1. COA-082846-2020

515-517 North 28th Street

Commission of Architectural Review

STAFF REPORT

Figure 5. 1905 Sanborn Map

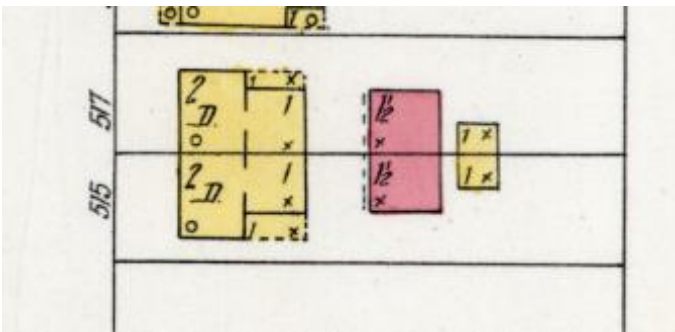
The applicant is proposing to demolish an existing 1-story massing at the rear of the homes. This section of the building has a gable roof, side porches, and a central chimney. Though the date of construction of this section of the building is unknown, it does appear on the 1905 Sanborn map of the property. The application and plans mention that this area of the building is in disrepair; however, only one photograph was submitted with the application. Staff is unable to determine whether the proposed demolition meets the requirements for demolitions listed in the City Old and Historic District ordinance. Staff requests the applicant submit additional information such as photographs or an engineer’s report indicating the building’s structural integrity for final review.
